Design Review Board Study Session

SUBJECT: DR14-35, MULTIPURPOSE BUILDING AT
TRILOGY AT POWER RANCH

DR14-35, Multipurpose Building at Trilogy at Power Ranch - Site plan, landscape plan, grading and drainage, elevations, floor plans, lighting, colors and materials for approximately 4.2 acres located south of the southwest corner of Ranch House Parkway and Village Parkway, zoned Public Facility/ Institutional (PF/I) with a Planned Area Development (PAD) overlay.

DR14-35
Attachment 5: Elevations
November 13, 2014

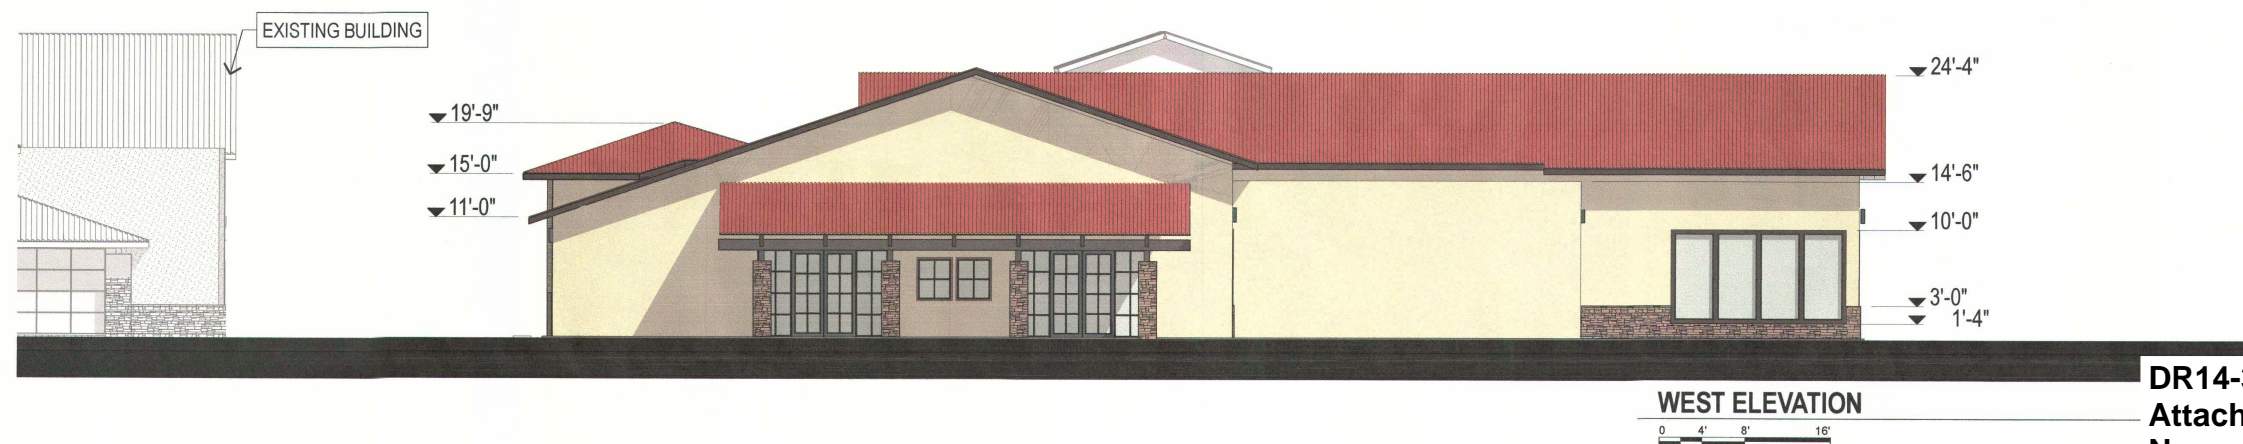
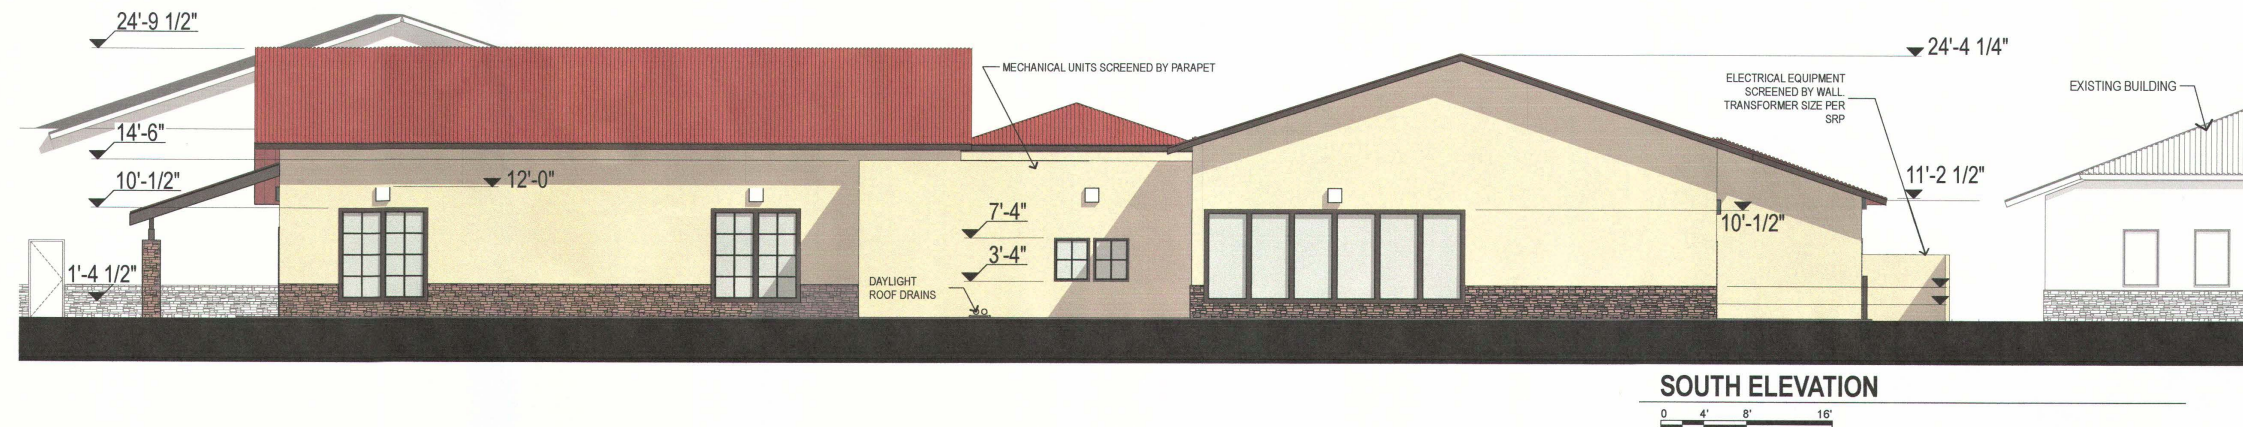
- Additional evaluation of the proposed materials (where the original is no longer available)
- Additional evaluation of the site's parking capacity
- Discussion of the east and west building elevations (is additional horizontal activity needed)
- The application does not include hardscape details for the pedestrian areas
